Work Order ID 160553

DESIGN <i>CP</i>	DRAWN BY <i>CP</i>	DART AEROSPACE LTD HAWKESBURY, ONTARIO, CANADA	
CHECKED <i>#</i>	APPROVED <i>#</i>	DRAWING NO. D3016	REV. A SHEET 1 OF 3
DATE 01.05.18		TITLE SEAT FRAME ASSEMBLY	SCALE NTS
A	01.05.18	NEW ISSUE

DRAWING NO. D3016	TITLE SEAT FRAME ASSEMBLY	REV. A	DART AEROSPACE LTD ENGINEERING ORDER	D.E.O. NO. D3016-A-1	SHEET NO. SHEET 1 OF 1	SCALE NTS
DRAWN <i>1</i>	CHECKED <i>UP</i>	MFG. APPR. <i>RE</i>	APPROVED <i>WAP</i>	DE APPR. <i>TH</i>		
DATE 10.01.29	DATE 10.01.29	DATE 10.01.29	DATE 10.01.29	DATE 10.01.29

TO REVISE D3016-11 SADDLE'S HOLE SIZES

D3016-11 SADDLE

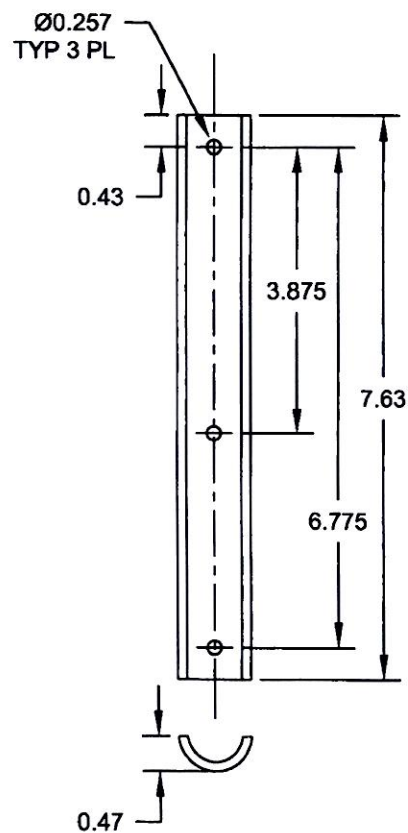
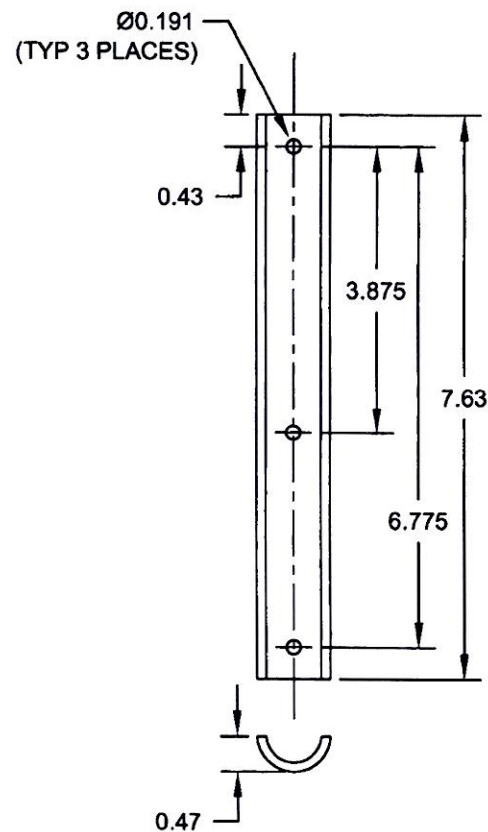
DETAIL D3016-11 SADDLE (SHEET 3): Ø0.257 TYP 3 PL WAS Ø0.191 (TYP 3 PLACES) AS SHOWN:
